# PLANNING AND ZONING CASE CHECKLIST

P&Z CASE # SP2020-017 P&Z DATE 08/11/20 CC DATE 08/18/20 APPROVED/DENIED  
ARCHITECTURAL REVIEW BOARD DATE \_\_\_\_\_ HPAB DATE \_\_\_\_\_ PARK BOARD DATE \_\_\_\_\_

07/24/2020: SP2020-017; Site Plan for 407 W. Washington Street

- I.1 This is a request for the approval of a Site Plan or an office building on a 0.28-acre parcel of land identified as Lot 2-R, Block A, Washington Place Addition, City of Rockwall, Rockwall County, Texas, zoned Downtown (DT) District, addressed as 407 W. Washington Street.

S1.0

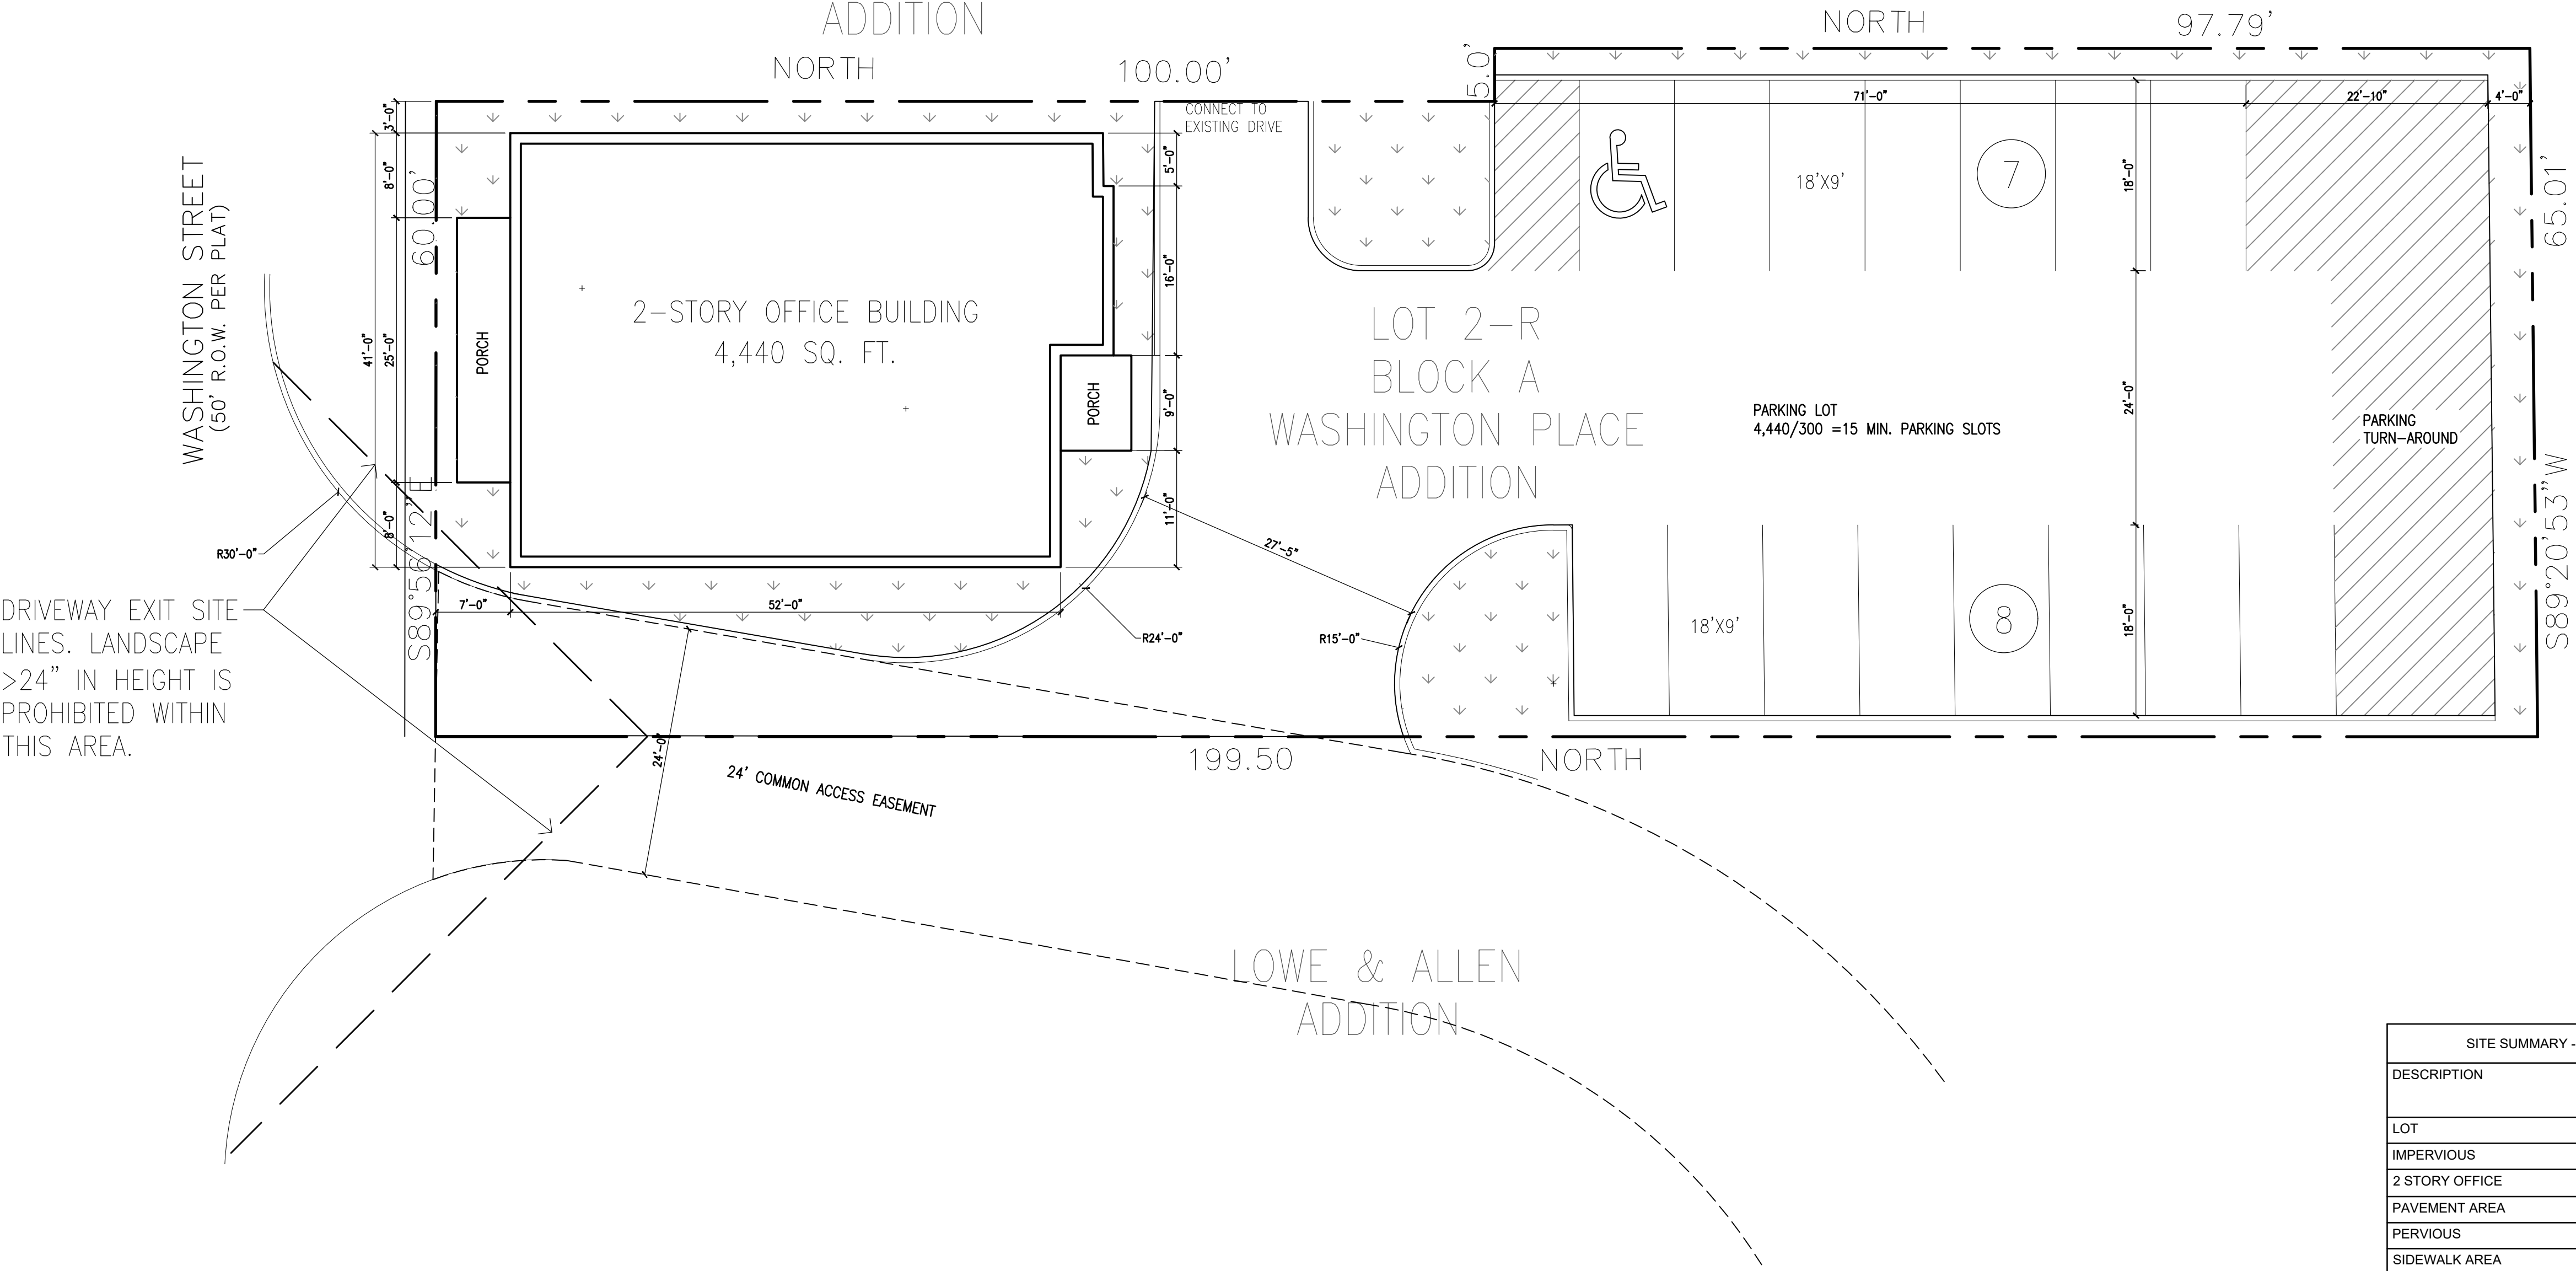
M.9 Site Plan. Please make the following clarifications on the site plan to ensure staff can properly review this project and convey all of the required elements to the City's boards and commissions (§03.04, Art. 11, UDC):

- 1) Indicate the wall lengths of all buildings on the site. (§03.04.B, Art. 11, UDC)
- 2) Indicate the distance between all property lines and existing and planned buildings located on the site. (§03.04.B, Art. 11, UDC)

- 3) Indicate all building setbacks adjacent to right-of-way. The Downtown (DT) District requires a build-to-line of 24-feet. Indicate on plan the build-to-line. (§04.07.C(4)(d)(1), Build-To-Lines, Art. 05, UDC)

- 4) Indicate all utilities both existing and proposed. Provide labels for all easements (i.e. utility, detention, drainage, etc.) (§03.04.B, Art. 11, UDC)

- 5) Indicate all drive widths. Provide dimensions. (§03.04.B, Art. 11, UDC)
- 6) Indicate the street centerline for all existing and proposed streets. (§03.04.B, Art. 11, UDC)

- 7) Indicate location of all Fire Hydrants. (§03.04.B, Art. 11, UDC)
- 8) Provide a label for all Firelane to indicate "24-ft Firelane, Public Access, Drainage, & Utility Easement", as appropriate for existing and proposed. (§03.04.B, Art. 11, UDC)

- 11) Indicate the type and depth of the paving material and provide a detail or cut-sheet. All required parking and loading areas shall be constructed of concrete, but may have a surface treatment of brick, stone or other similar material. (§03.02, Art. 06, UDC)

- 12) All buildings must be designed such that no roof mounted mechanical equipment, HVAC, or satellite dishes shall be visible from any direction. Dash-in RTU's and provide screening detail. (§01.05.C, Art. 05, UDC)

A TREESCAPE PLAN

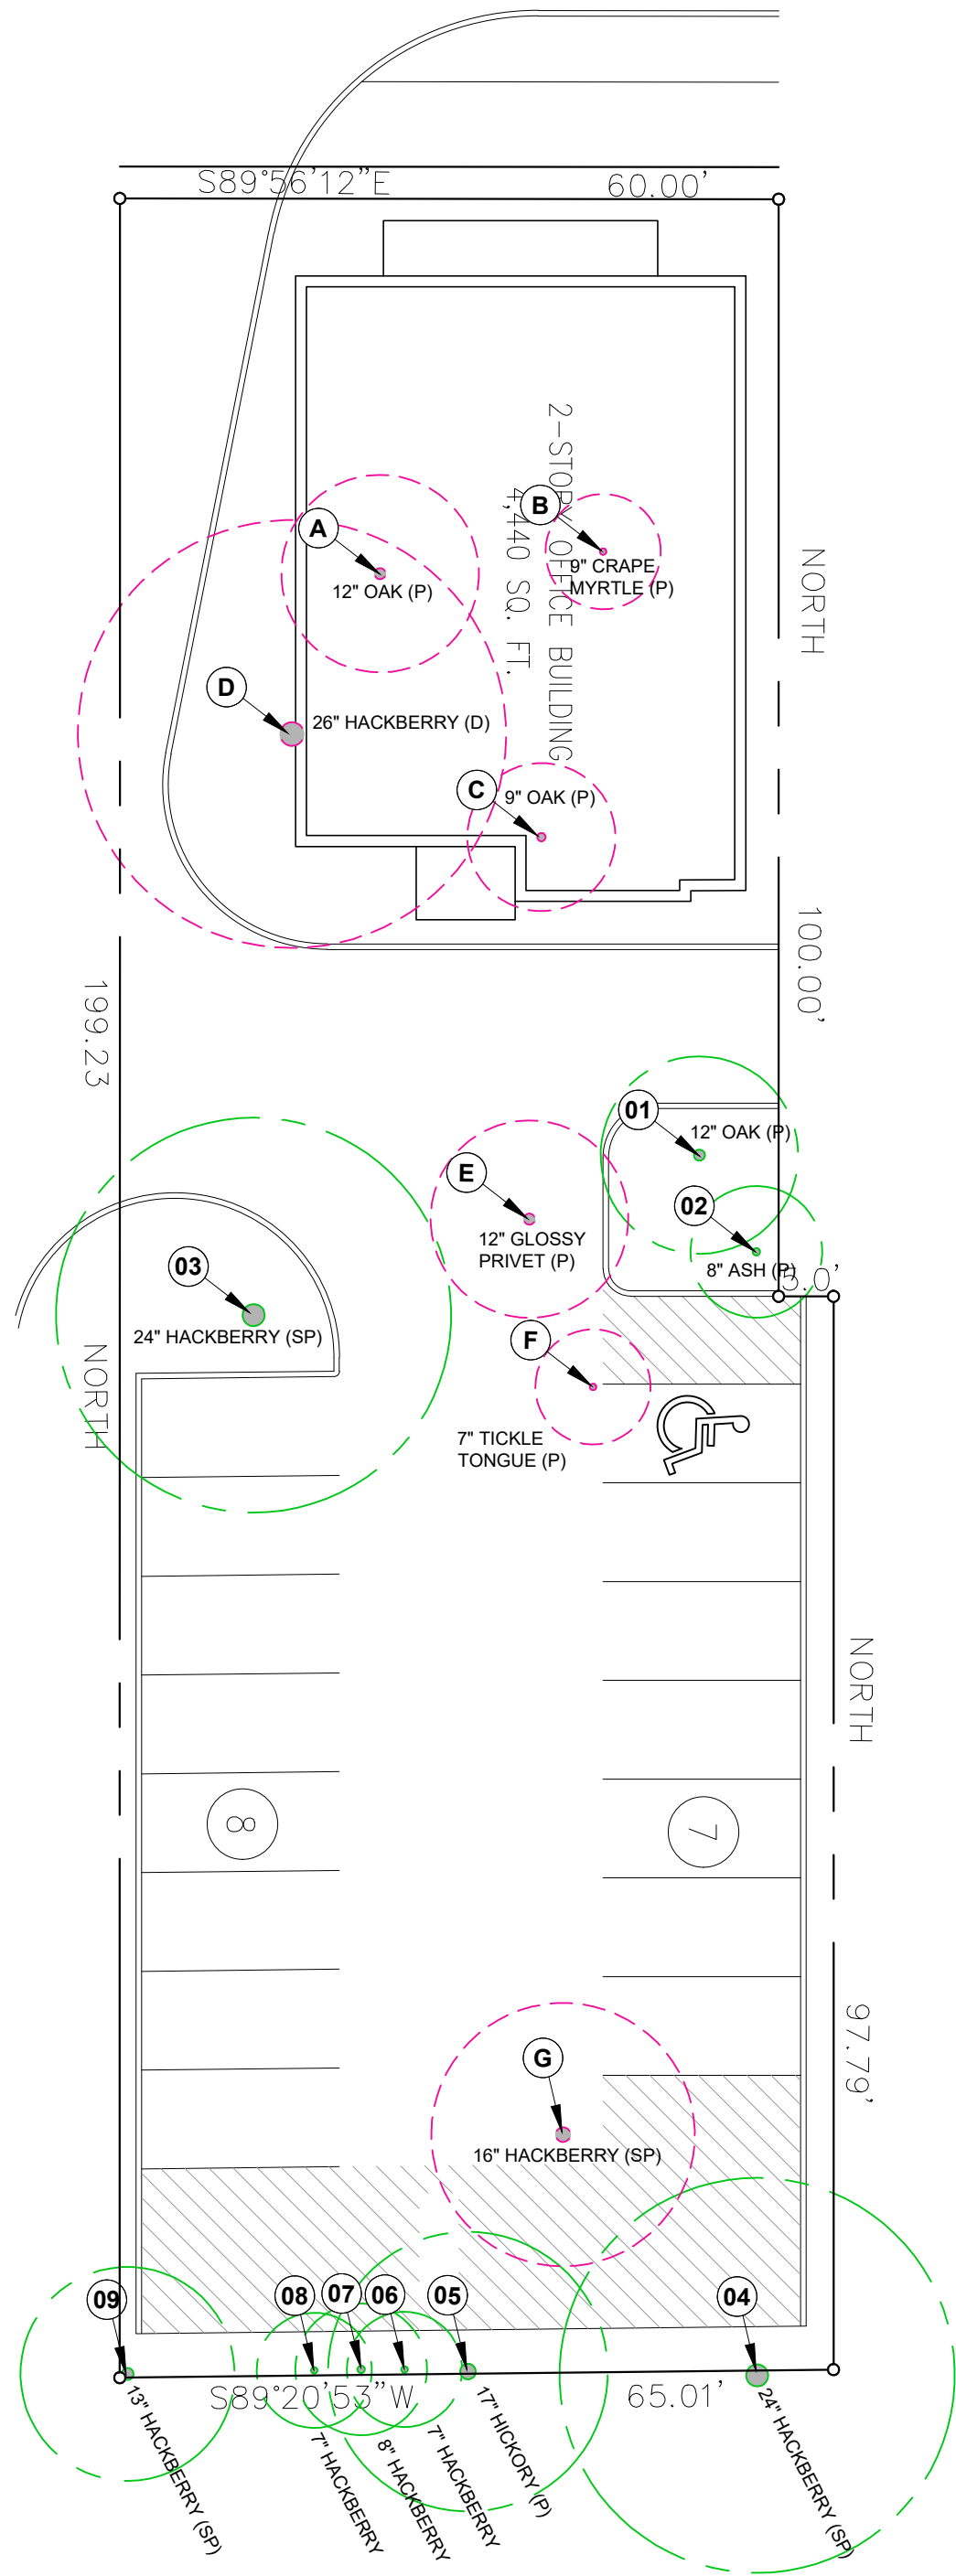
I.10 Treescape Plan. According to Section 3.4, Treescape Plan Review Process, of Article 09, of the UDC, The planning and zoning commission will review and approve or disapprove the treescape plan. The decision of the Planning and Zoning Commission may be appealed to the city council. The treescape plan requires approval by the Planning and Zoning Commission as submitted.

- 1) Indicate all Site Elevations, Grades, Major Contours and the Limits of Construction. Use a heavier gray scale for contours and indicate all of the amenity center building footprint. (§03.01.E, Art. 09, UDC)
- 2) Tree Removal Schedule note indicates Tree #D (i.e. 26-inch Hackberry) has been determined to be diseased by Arborist. Please provide a copy of the letter of determination for relief of mitigation of this tree. (§01.03.B, Art. 09, UDC)

L2.1

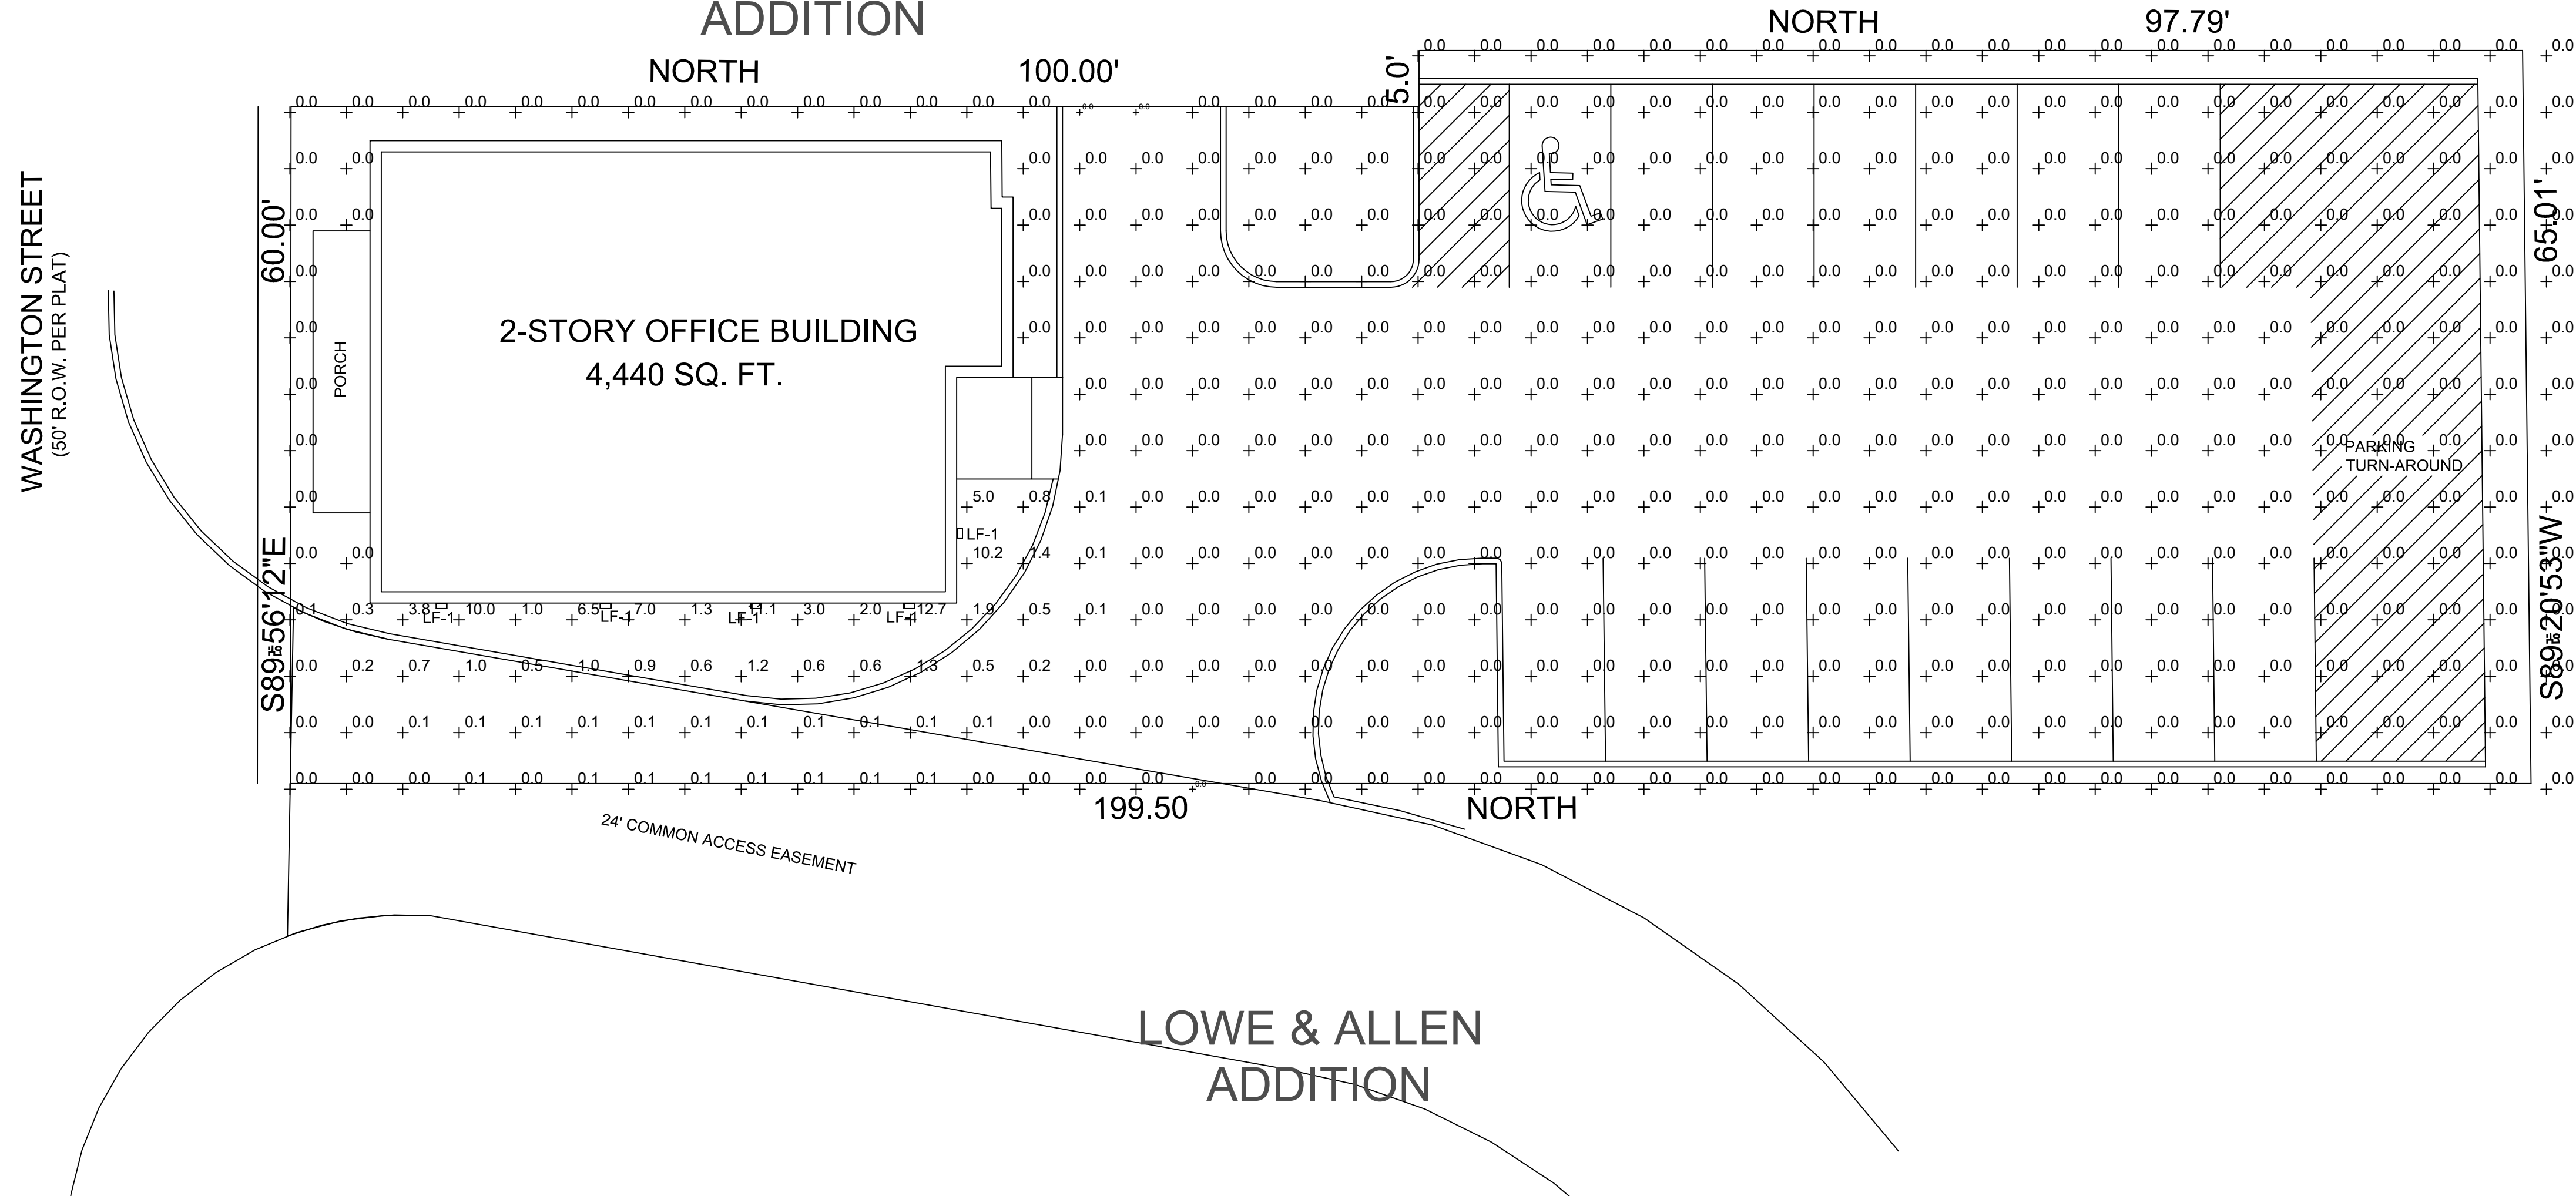
M.8 Landscape Plan. Please make the following clarifications and changes to the landscape plan to ensure staff can properly review this project and convey all of the required elements to the City's boards and commissions (Sec. 2, Art. 08, UDC):

- 1) Indicate the locations and dimensions of the required landscape buffers. SH-66 Overlay (SH-66 OV) requires a minimum 20-foot landscaper buffer. Dimension and provide a label for the landscape buffer. (§06.02.E.1.b, Art. 05, UDC)

- 2) Correct the Excerpts from Rockwall Landscape Standards for street landscaping. The subject property is located within the SH-66 Overlay (SH-66 OV) requires a minimum 20-foot landscaper buffer. (§06.02.E.1.b, Art. 05, UDC)

- 3) Correct the Landscape Plant Schedule of sheet L2.1 to indicate a minimum of 5-gallon size for all shrubs being considered. (§06.02.E.2, Art. 05, UDC)

- 4) No grade change in excess of two (2) inches shall be allowed within the drip line of any protected or featured tree unless adequate construction methods are approved beforehand. What measures are being taken for the protection of the critical root zones for the existing trees within the parking lot? (§07.05, Art. 09, UDC)

**SITE PLAN**  
SCALE: 1"=10'  
0 10 20

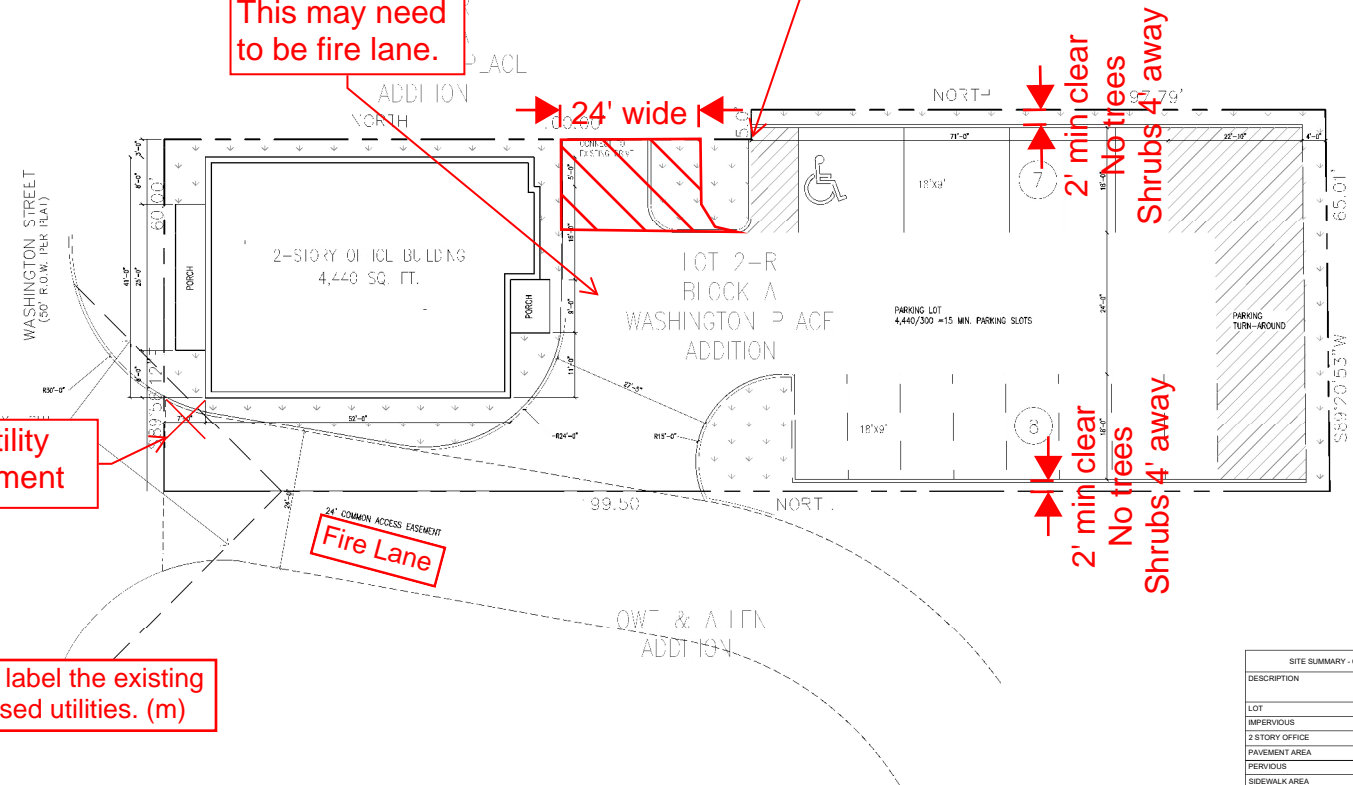
Adequate fire lane coverage? This may need to be fire lane.

Crossing property lines?

- 4% Engineering inspection fees (i)
- Engineering review fees apply (i)
- Impact fees. (i)
- Min 20' utility easements. (i)
- No structures in easements. (m)

- Detention was accounted for in the 405 W Washington plans. (i)
- No walls in utility esmts (m)
- 10' U.E Required along ROW (m)
- Will need TxDOT driveway and utility permits. (i)

Show and label the existing and proposed utilities. (m)
